ADDENDUM TO BID DOCUMENTS

Pleasanton Unified School District	ADDENDUM 02
	Project: Staff Parking / Ballfield Fence at Foothill High School Project (2021-22.13)
	Date: April 20, 2022

DRAWING TITLE
**ENLARGED
FENCING REMOVAL
SITE PLAN
N/W CORNER**

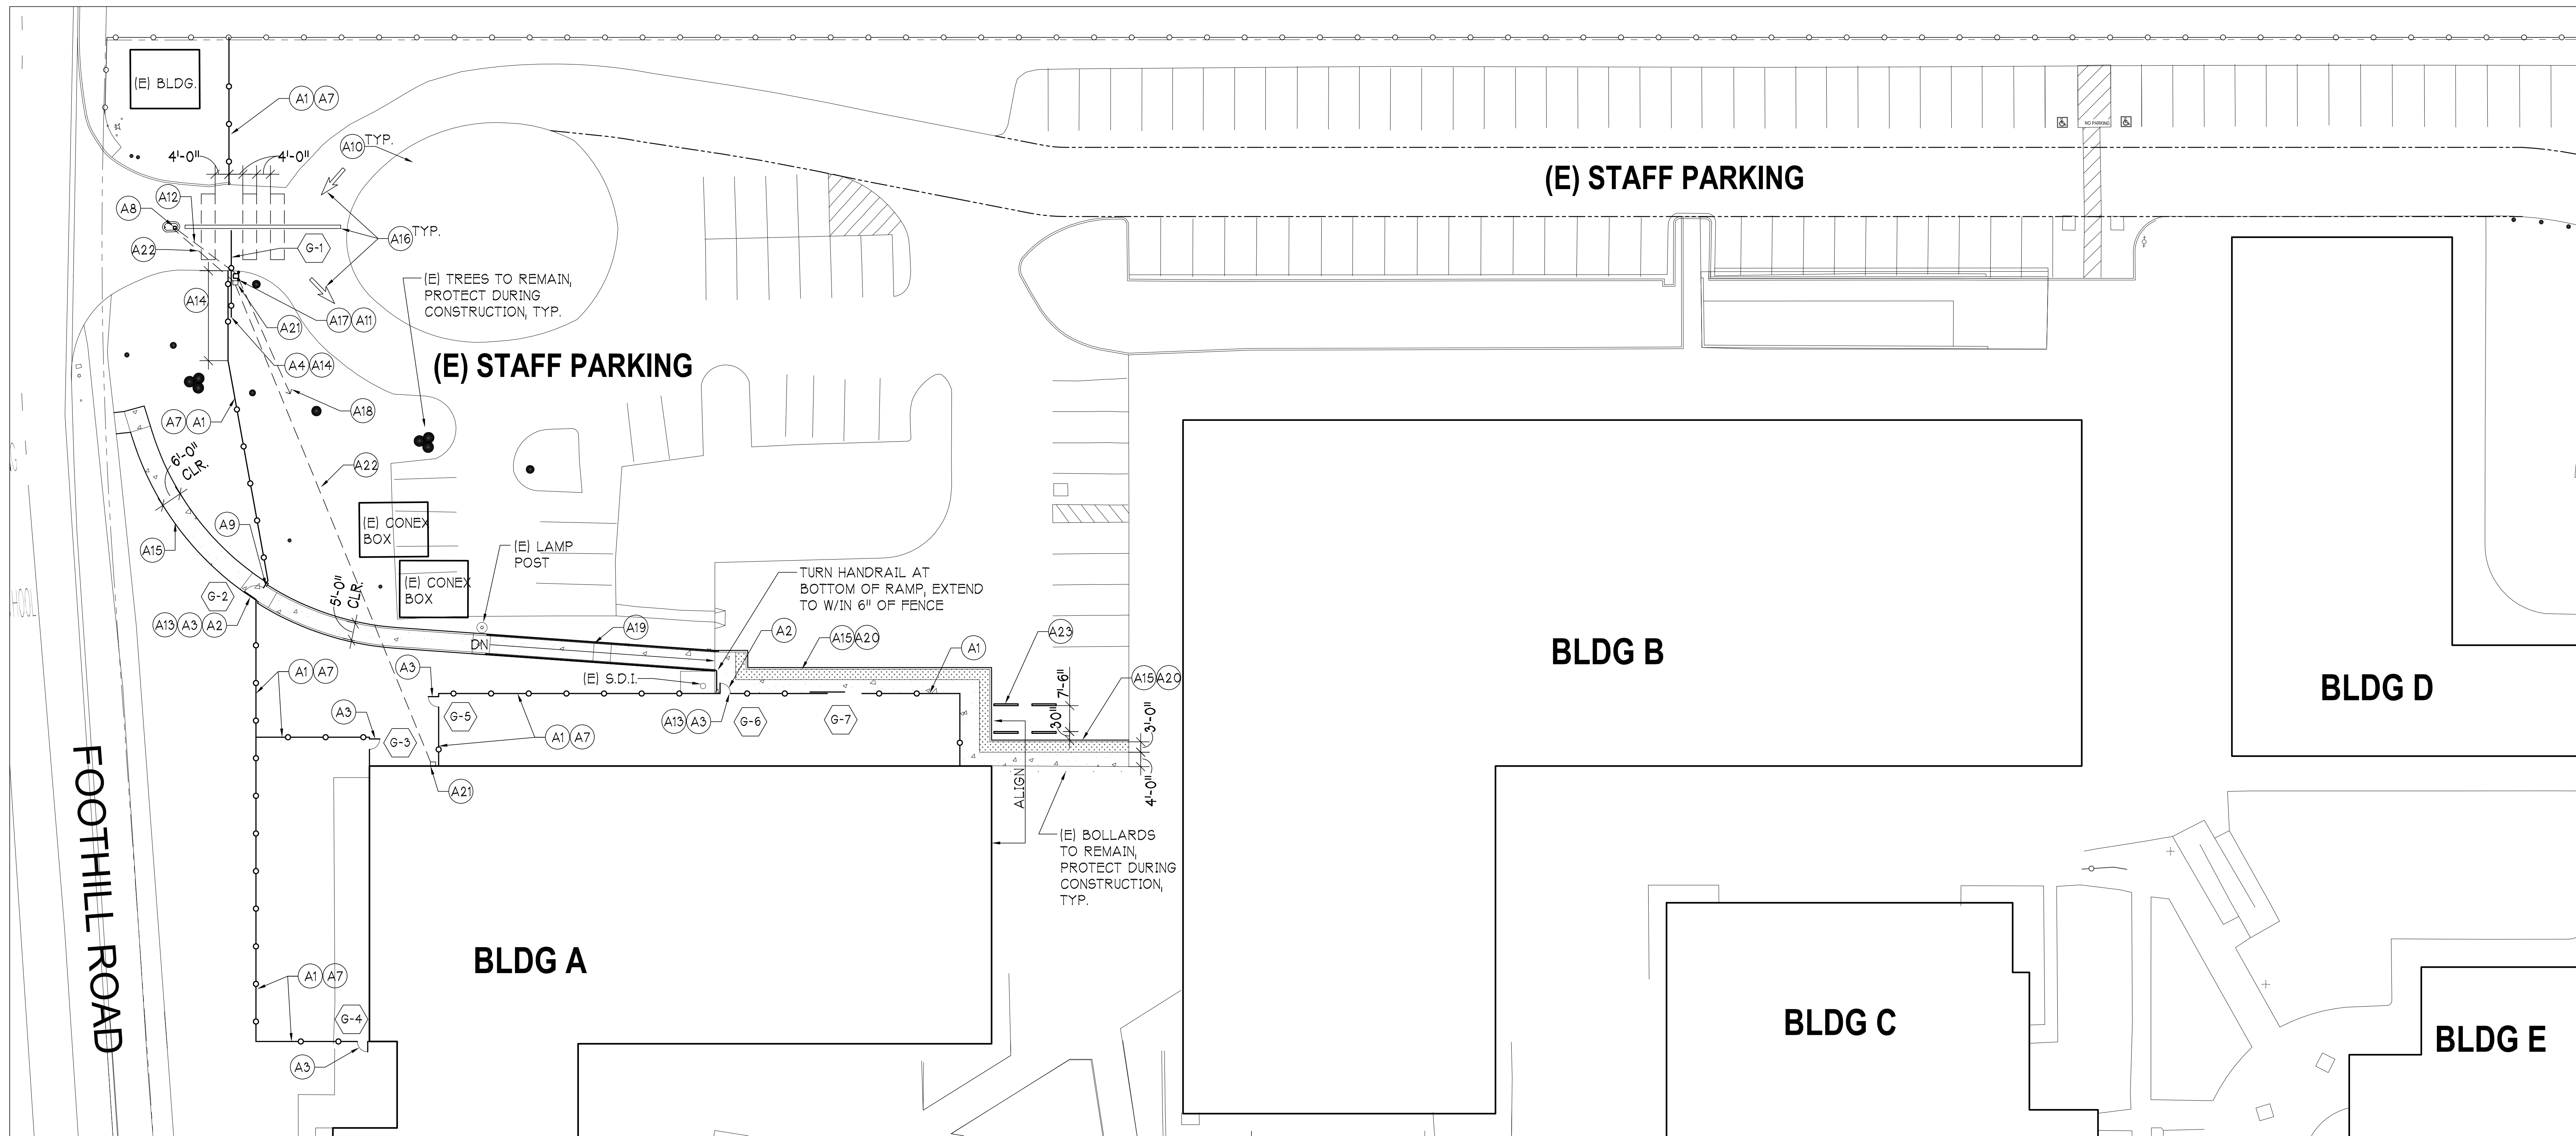
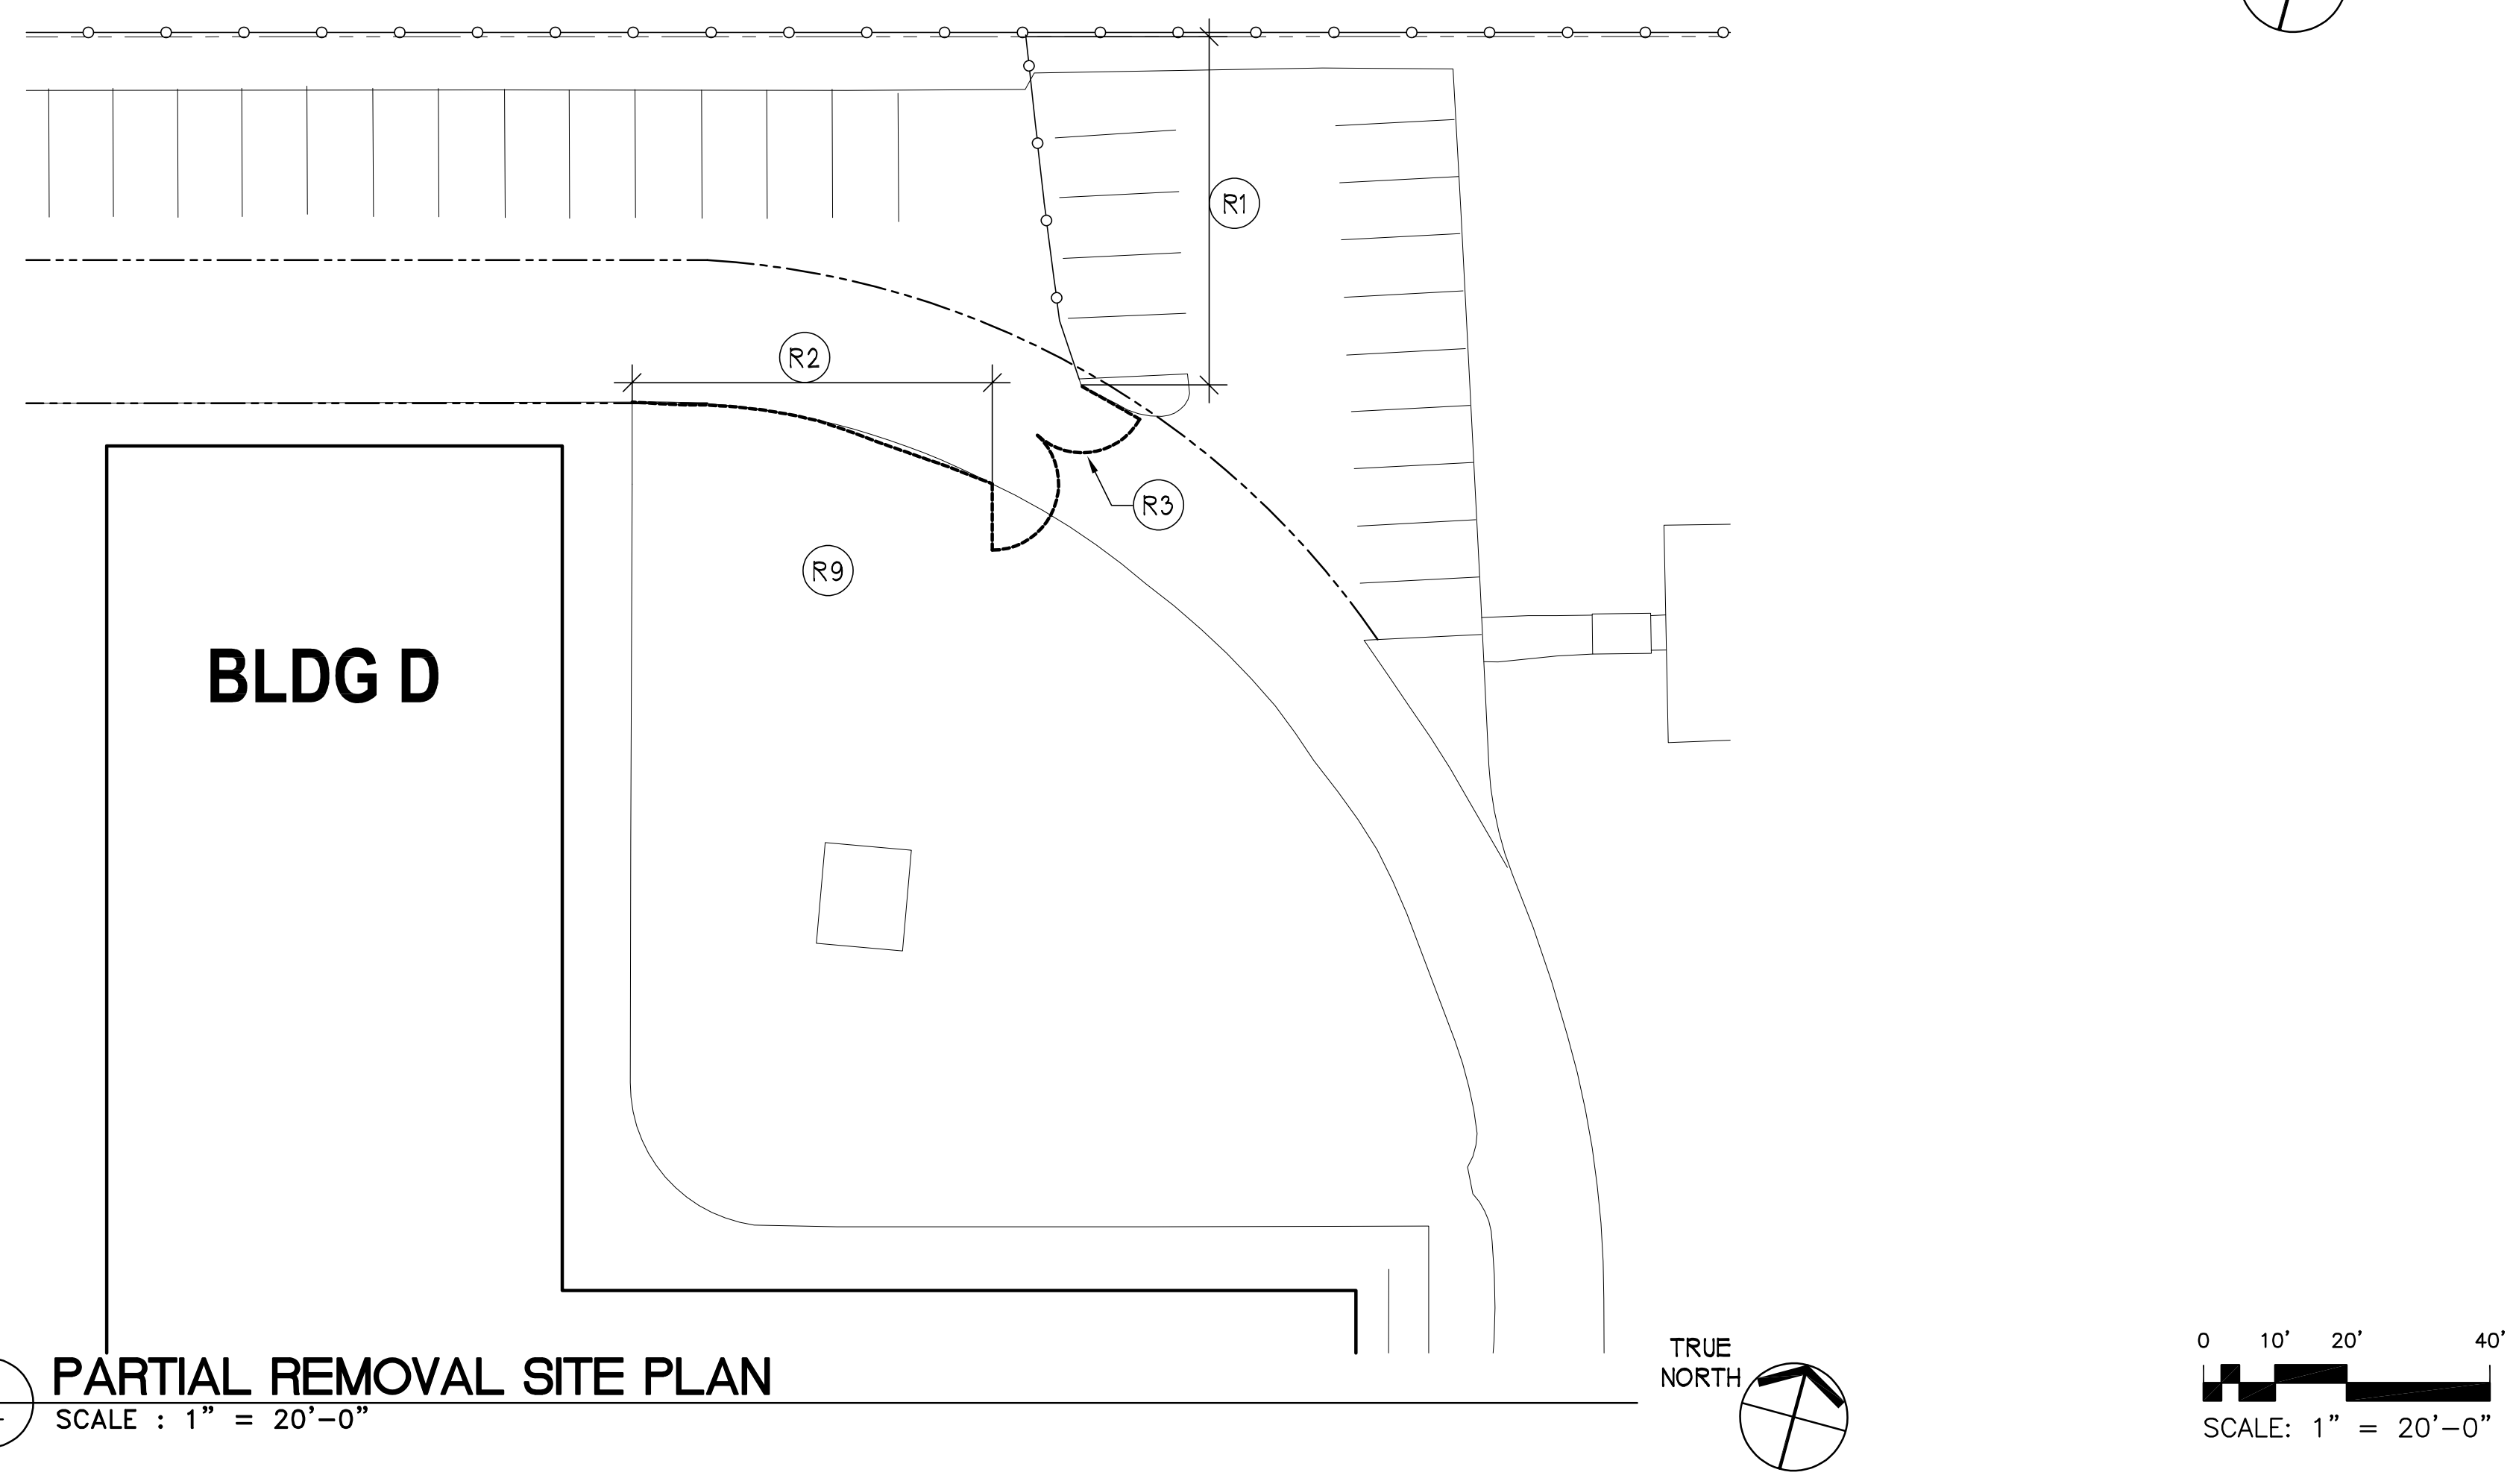
1. **Subject:** Added Removal Note R13

Reference: A1.1

Description of Change: Replace sheet A1.1 in its entirety

LEGEND	GENERAL NOTES	REMOVAL NOTES
<div><div><div></div><div>EXISTING PROPERTY LINE LINE</div></div><div><div></div><div>EXISTING FENCE TO REMAIN</div></div><div><div></div><div>ITEM TO BE REMOVED</div></div><div><div></div><div>(E) 20'-0" WIDE FIRE ACCESS</div></div><div><div></div><div>AC PAVING TO BE REMOVED, S.C.D.</div></div></div>	<div>A. PROVIDE ANY AND ALL REMOVAL WORK NECESSARY TO ALLOW FOR INSTALLATION AND/OR CONSTRUCTION OF WORK TO BE PROVIDED</div> <div>B. RETAIN AND REINSTALL ALL (E) SIGNAGE AT FENCES AND GATES. VERIFY LOCATION WITH DISTRICT.</div> <div>C. SALVAGE AND RETURN ANY PADLOCKS AND CHAINS THAT ARE REMOVED TO DISTRICT.</div> <div>D. PROVIDE NEW FENCE AND GATES AS INDICATED. WORK SHALL INCLUDE ALL FOOTINGS, MATERIALS, HARDWARE, ETC. NECESSARY FOR COMPLETE INSTALLATION. IRRIGATION AND UTILITY LOCATIONS SHOWN ARE ESTIMATED AND NEITHER VERIFIED NOR COMPLETE. CONTRACTOR MUST ENGAGE THE SERVICES OF AN UNDERGROUND LOCATOR TO PERFORM A COMPLETE SURVEY OF EFFECTED AREAS PRIOR TO FENCE LAYOUT.</div> <div>F. CONTRACTOR TO CONFIRM FIELD CONDITIONS AND POSSIBLE OBSTRUCTIONS AT (E) BUILDING FOOTINGS, BEFORE SETTING LOCATIONS OF FENCE POSTS. SUBMIT SHOP DRAWINGS FOR PROPOSED FENCE POST LAYOUT, FOR REVIEW BY ARCHITECT AND OWNER.</div> <div>G. CONTRACTOR IS TO LAY OUT LOCATION OF NEW FENCE AND GATES PRIOR TO STARTING CONSTRUCTION. CONFIRM LAYOUT WITH DISTRICT.</div> <div>H. ALL GATES MARKED FIRE DEPT. ACCESS MUST PROVIDE MIN 20'-0" CLEAR PASSAGE FOR FIRE DEPARTMENT EQUIPMENT. POSTS, HINGES, HARDWARE, ETC MAY NOT ENCROACH. GATES SHOULD SWING 180°.</div> <div>I. REFER TO SPECIFICATIONS FOR ADDITIONAL INFORMATION AND GATE HARDWARE.</div> <div>J. PEDESTRIAN GATES ARE TO PROVIDE MINIMUM CLEAR OPENING OF 32 INCHES. WHERE A GATE IS BEING REPLACED IN AN EXISTING OPENING, VERIFY EXISTING OPENING IS SUFFICIENT TO ACCOMMODATE NEW CLOSER, GATE AND HARDWARE AND STILL PROVIDE 32 INCH ACCESSIBLE CLEARANCE.</div> <div>K. PROVIDE DOUBLE LOOP AND 12" CHAIN WELDED TO GATE POST AT GATES WHERE PADLOCKS ARE SCHEDULED.</div> <div>L. VERIFY SIZE OF EXISTING GATES TO BE REPLACED IN FIELD. EXISTING GATE POSTS ARE TO REMAIN, UNO.</div> <div>M. WHERE EXISTING FENCES AND GATES ARE MODIFIED, PAINT AREA OF WORK TO MATCH EXISTING FINISH. SEE SPECIFICATIONS FOR ADDITIONAL INFORMATION.</div>	<div>(R1) (E) FENCE TO REMAIN, PROTECT DURING CONSTRUCTION.</div> <div>(R2) REMOVE PORTION OF (E) FENCE AS INDICATED.</div> <div>(R3) REMOVE (E) GATE AND POSTS.</div> <div>(R4) REMOVE (E) GATE OPERATOR/MOTOR, UNDERGROUND POWER & CONDUIT TO REMAIN.</div> <div>(R5) REMOVE (E) KEYPAD, (E) POST AND ELECTRICAL CONDUIT TO REMAIN.</div> <div>(R6) REMOVE PORTION OF (E) CONC. WALK, S.C.D.</div> <div>(R7) REMOVE PORTION OF (E) AC PAVING FOR INSTALLATION OF CONC. WALK, S.C.D.</div> <div>(R8) (E) AC PAVING TO REMAIN</div> <div>(R9) (E) LANDSCAPE AREA</div> <div>(R10) (E) CONC. ISLAND AND BOLLARD TO REMAIN. PROTECT DURING CONSTRUCTION</div> <div>(R11) SAWCUT AND REMOVE PORTION OF (E) CONC CURB TO ALLOW FOR CONCRETE WALK INSTALLATION</div> <div>(R12) REMOVE (E) CONC. MOW STRIP AND FOOTING TO ALLOW FOR PLACEMENT OF NEW FENCE, FOOTINGS AND MOW STRIP</div> <div>(R13) REMOVE AND RETAIN (E) BIKE RACKS FOR REINSTALLATION, TYP OF 4.</div>
